**AGENDA**  
**Cascade Charter Township Planning Commission**  
**Monday, October 19, 2015**  
**7:00 pm**  
**Cascade Library Wisner Center**  
**2870 Jacksmith Ave. SE**

TO: Cascade Charter Township Planning Commission  
FROM: Steve Peterson, Community Development Director  
REPORT DATE: October 13, 2015  
MEETING DATE: October 19, 2015  
CASE: #15-3260 / Lacks Corporate HQ expansion

Re: Lacks Corporate Office  
Site Plan Review

Utility locations are approximate only.  
 Please contact "Mira Dig" three working days prior to the start of construction for exact locations. (1-800-482-7171)

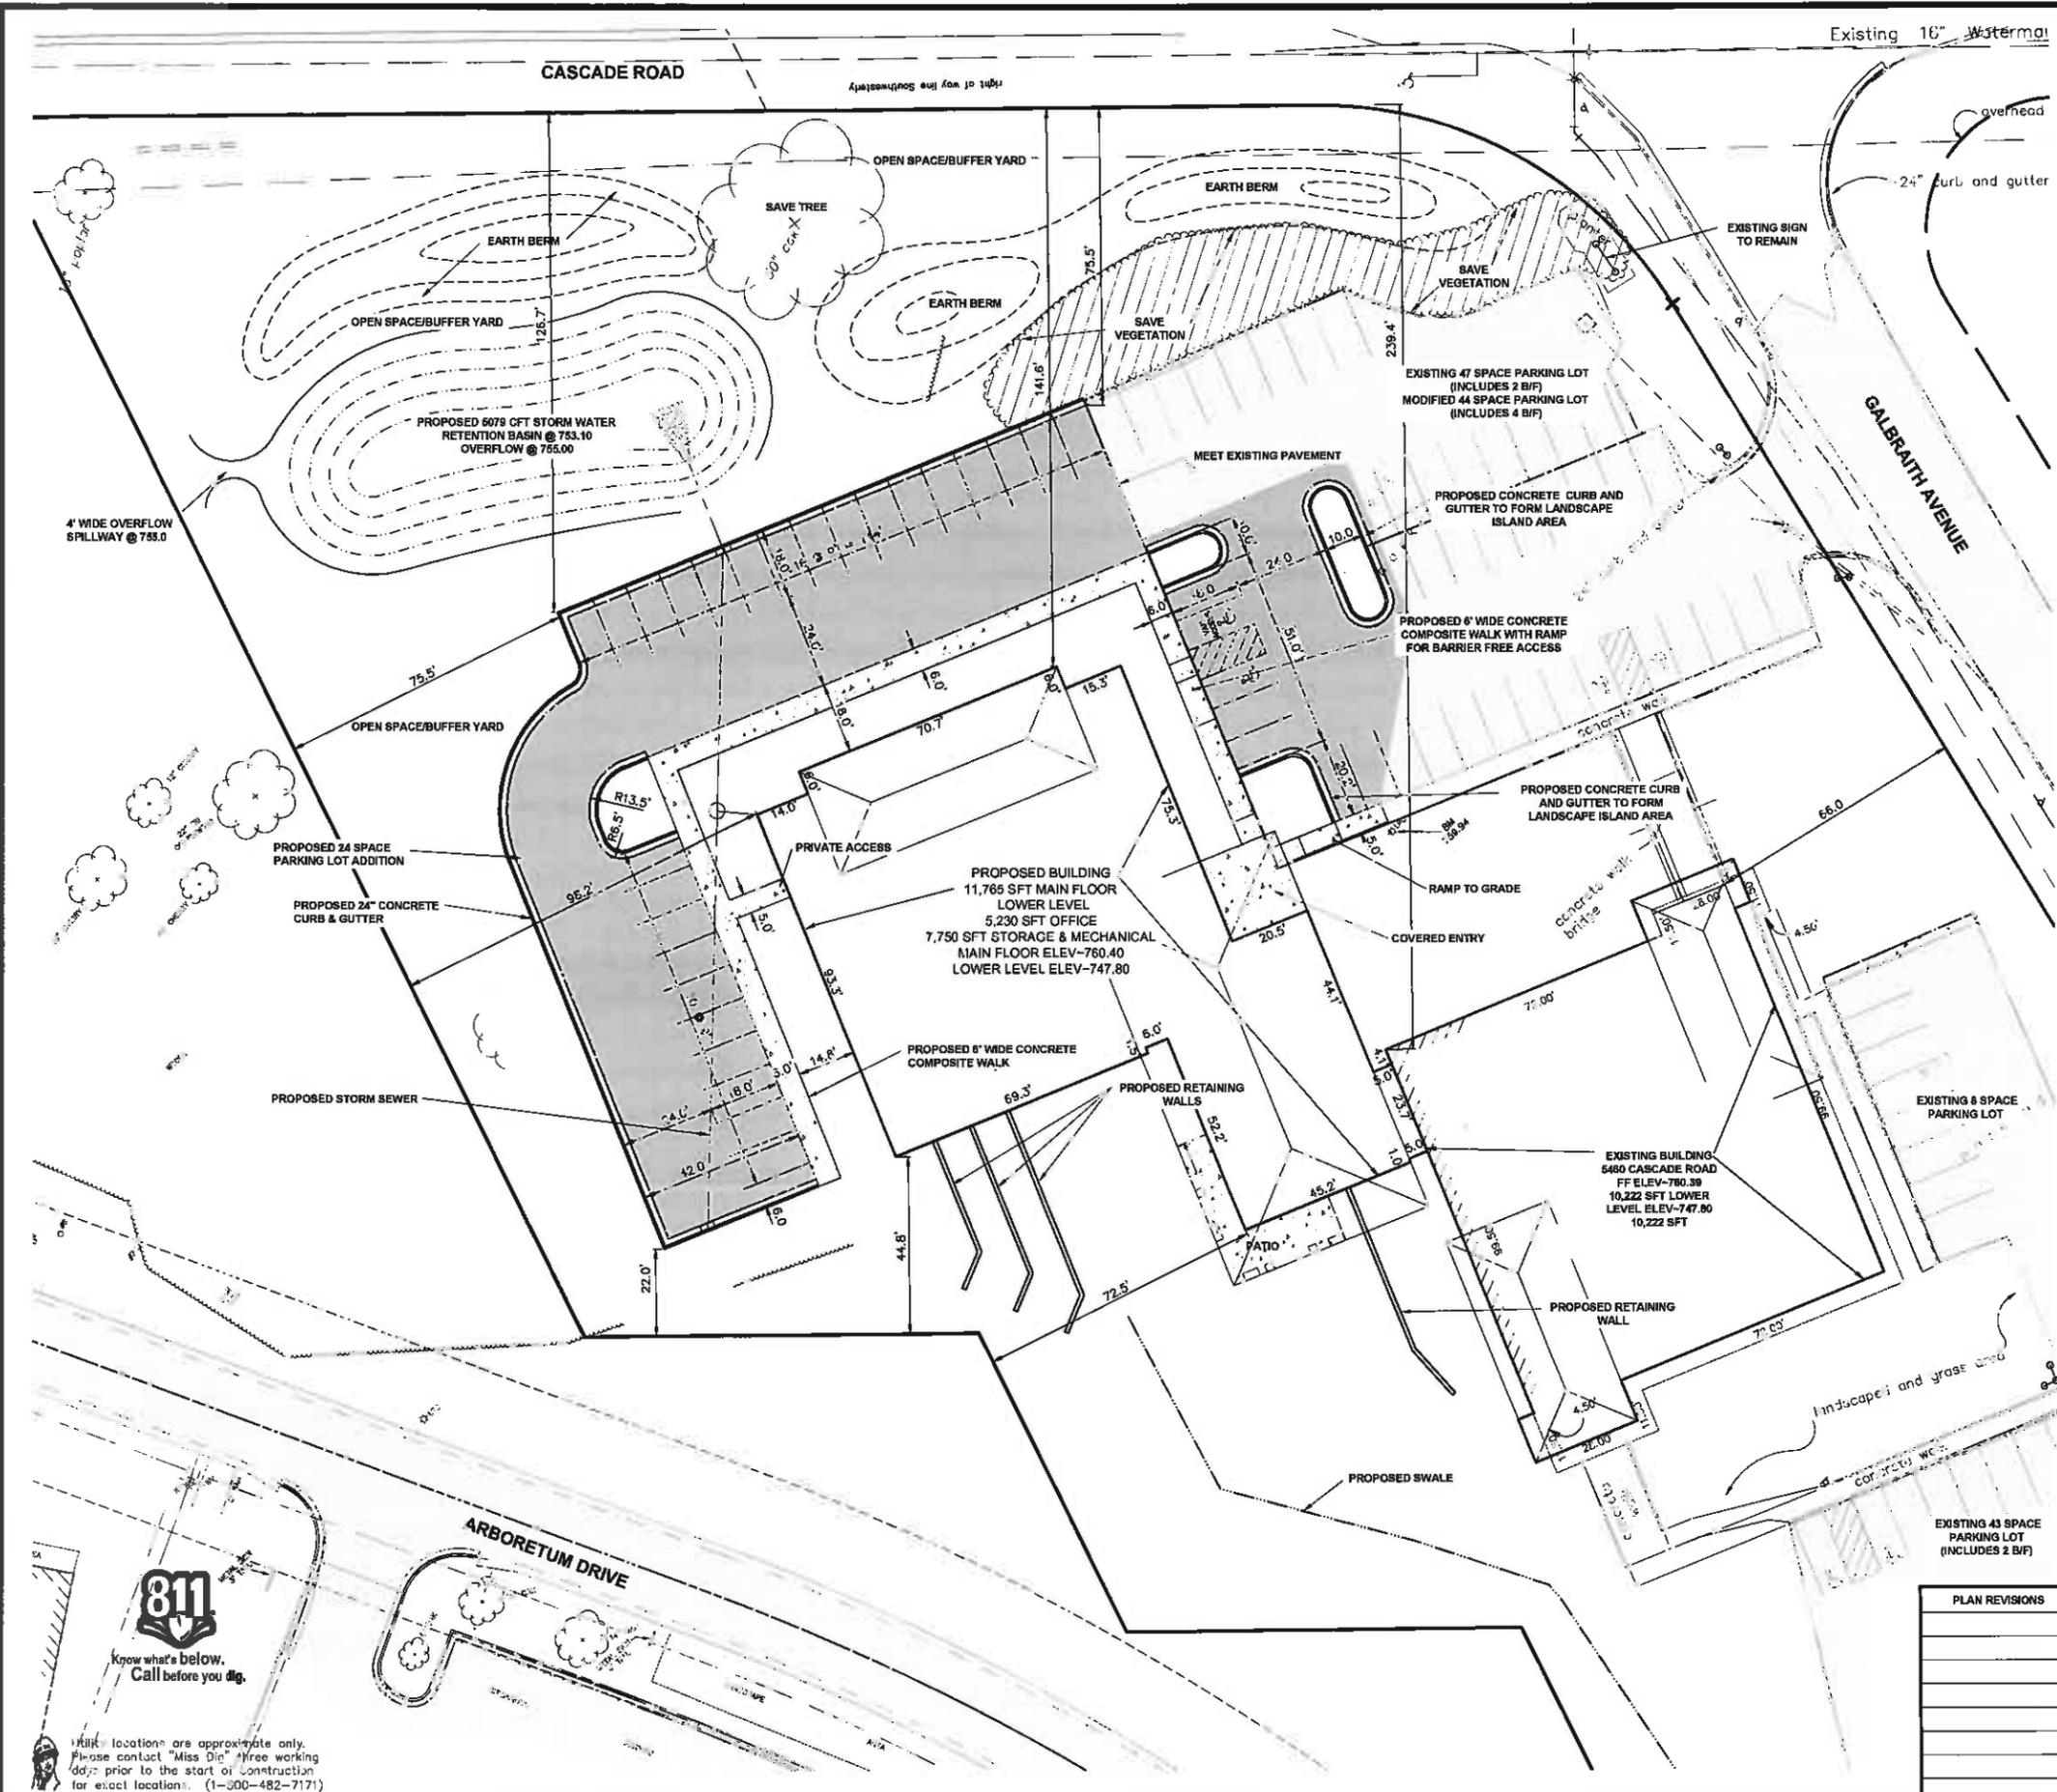
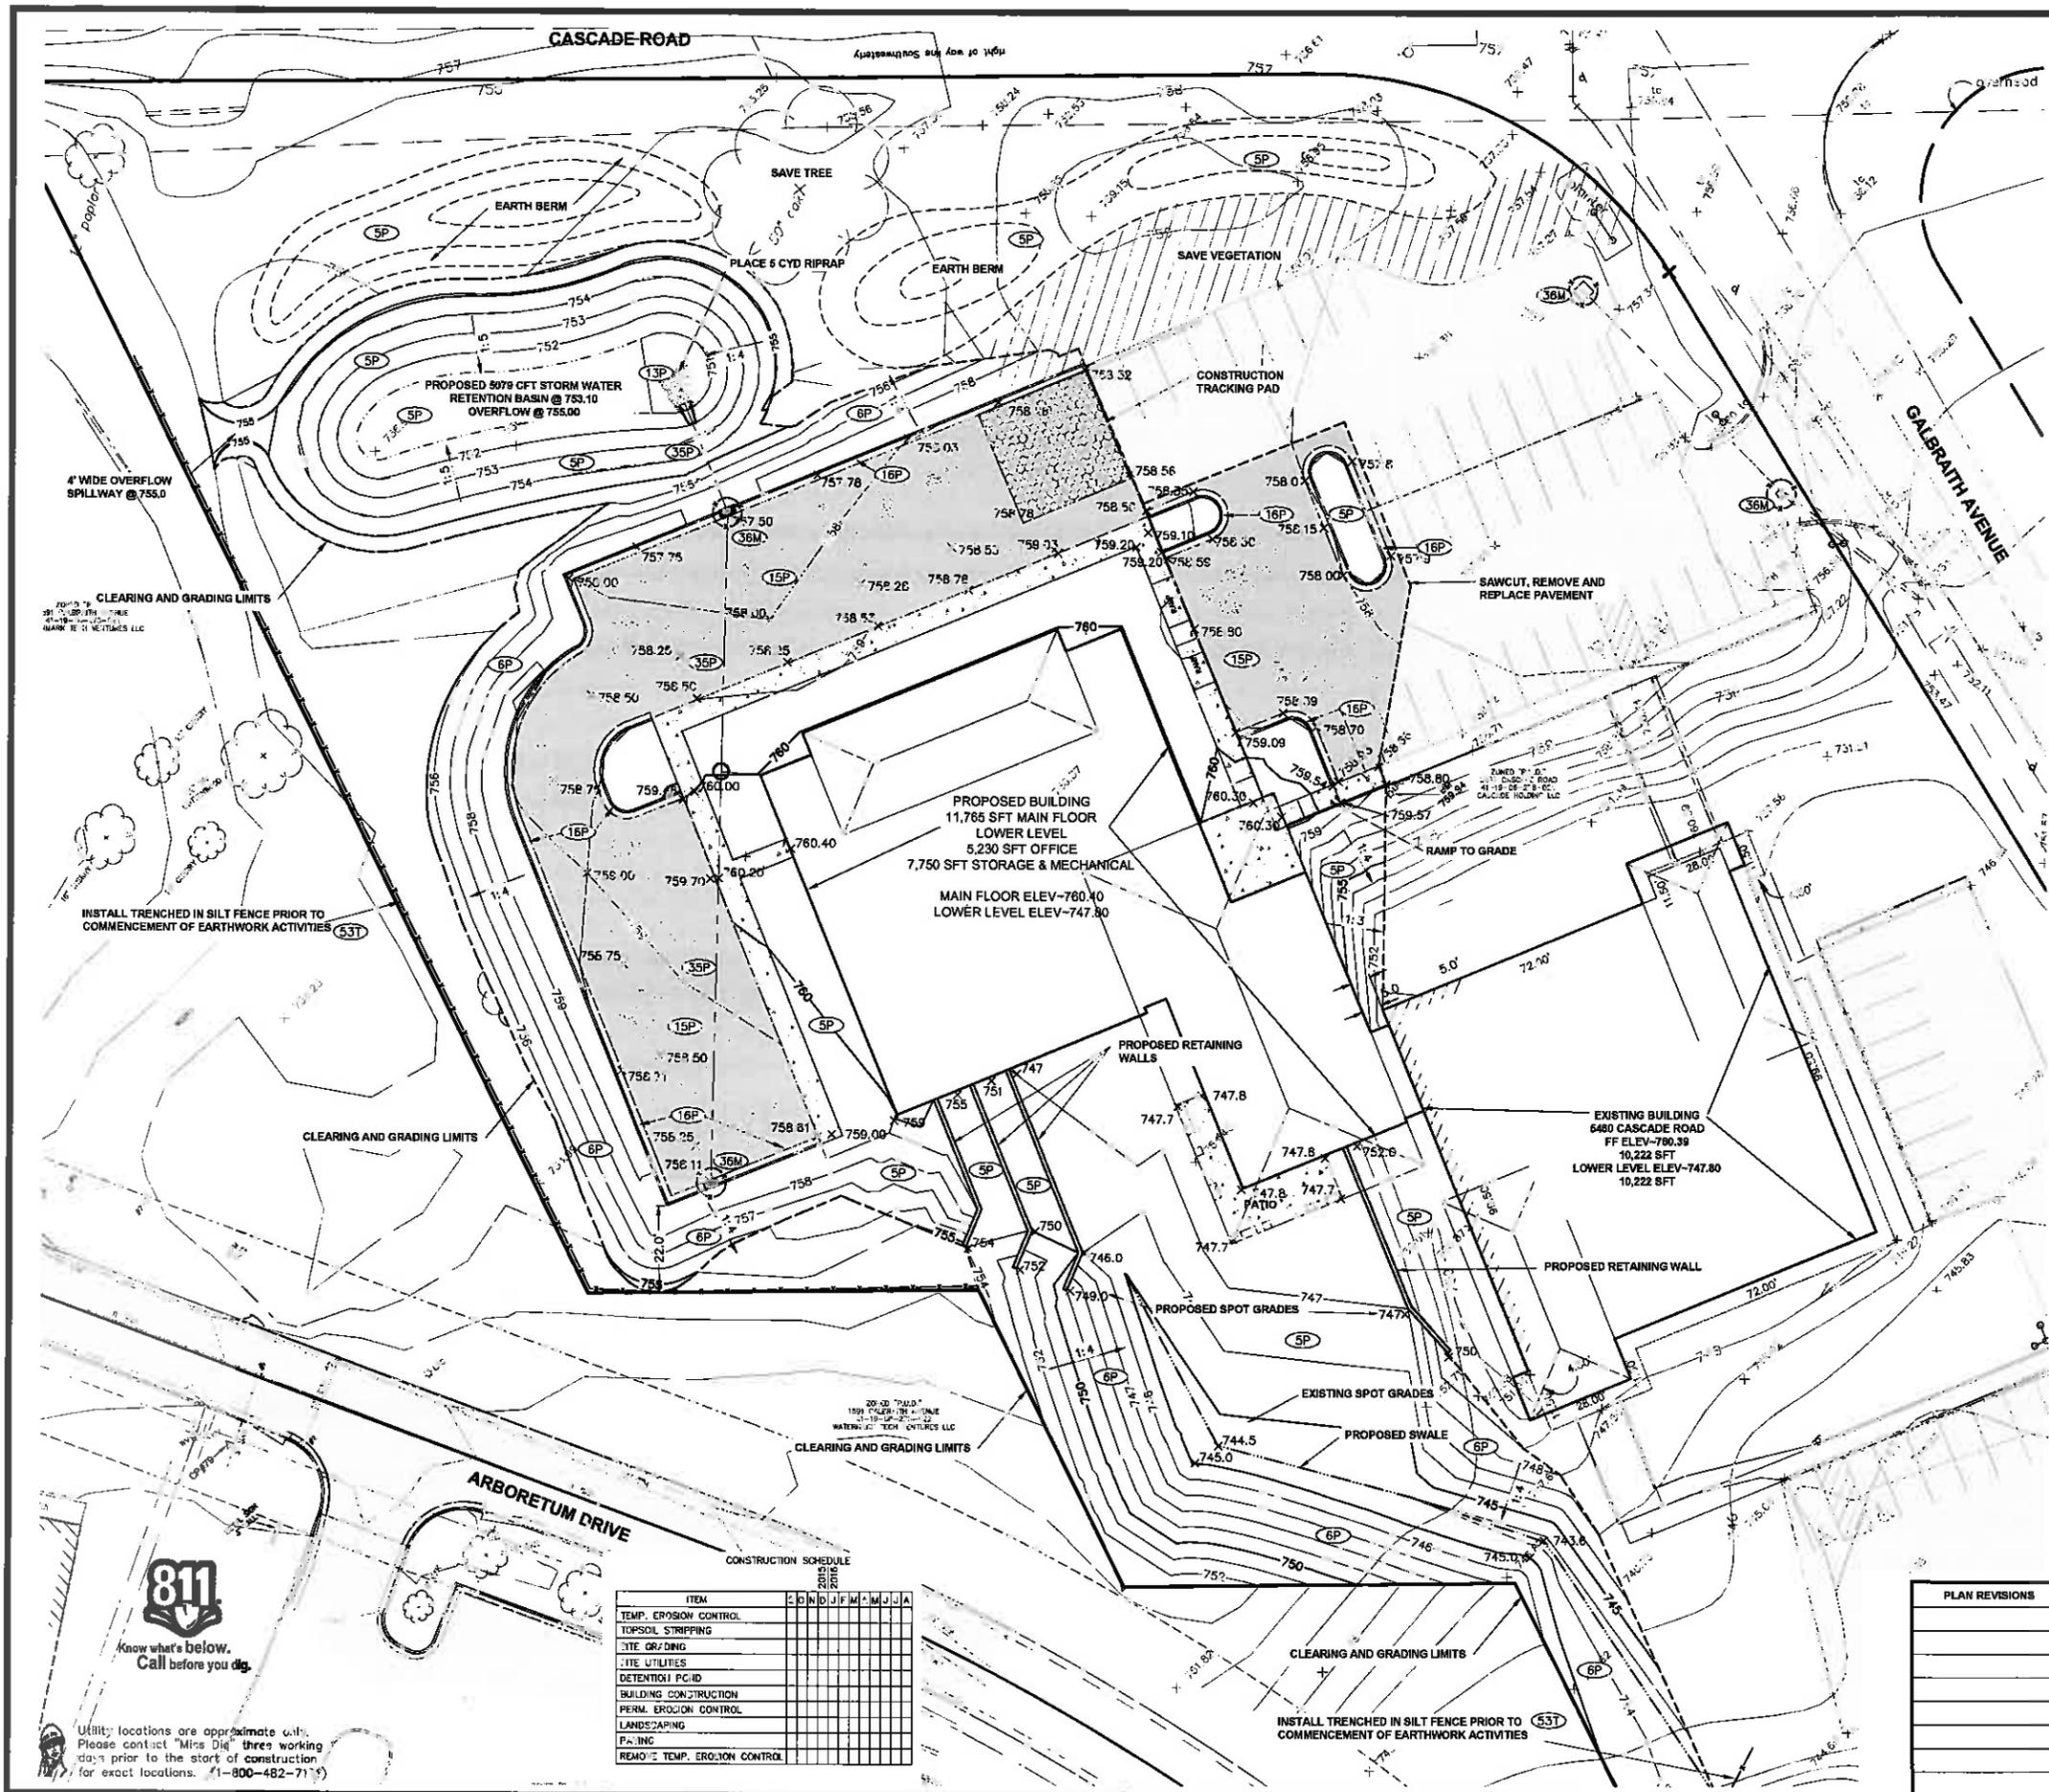
We reviewed the site plan for the Lacks Corporate Office, located at 5460 Cascade Road, prepared by Moore and Bruggink, Inc. The current site plan and the basis of this review are dated September 25, 2015. The proposed project includes a 24,745-square-foot building addition, parking lot expansion, and storm sewer improvements.

The applicant has submitted drawings, calculations, and additional documentation as required in the SWO Section 2.03, Drainage Plan. Please refer to the attached checklist for items and comments on each item. Please note a maintenance agreement is required before construction begins. The agreement should be submitted to the Township for review. The maintenance agreement and plan should include at a minimum, cleaning of catch basin sumps, sediment and debris removal from the infiltration basin, and landscape maintenance of the infiltration basin to maintain the design volume and ensure the system is operating as it was designed.

Soil Erosion and Sedimentation Control (SESC) measures are provided on the plan drawings. The applicant has included silt fence along the limits of clearing and grading, silt sacks in catch basins, and seeding with mulch at all disturbed areas of the site. SESC falls under the review and approval of the Kent County Road Commission and a permit is required before construction can begin. The SESC measures indicated on the drawings appear appropriate given the expected work.

The proposed stormwater design meets the Township SWO requirements for new developments. The applicant will need to apply for and obtain an SESC permit prior to beginning construction. We recommend approval of the site plan from an engineering standpoint.

- NR (11) Maintenance agreement, in form and substance acceptable to the Township, for ensuring maintenance of any privately owned stormwater runoff facilities. The maintenance agreement shall include the developer's written commitment to provide routine, emergency, and long-term maintenance of the facilities and, in the event the facilities are not maintained in accordance with the approved drainage plan, the agreement shall authorize the Township to maintain any onsite stormwater runoff facility as reasonably necessary, at the developer's expense  
*Maintenance agreement was not provided and is required.*

Listed below are items from the site plan review:

- Fire Lanes will be determined by the Fire and Building code Officials.
- Access to the site at all times during construction.
- Hydrants and spacing will be determined by the fire code official and the City of Grand Rapids water department. On plan hydrants are difficult to find, 300 feet spacing along access roads.
- Fire Department Connection (FDC) will be a 5" Stortz fitting with a 30 degree elbow.
- Address posted and visible from the roadway.
- Supra box installed for 24 hour access by Fire Department staff in case of an emergency.
- Access will need to be for fire trucks from Galbraith to Arboretum thru the new parking lot. Appears there are parking spaces on the plan.
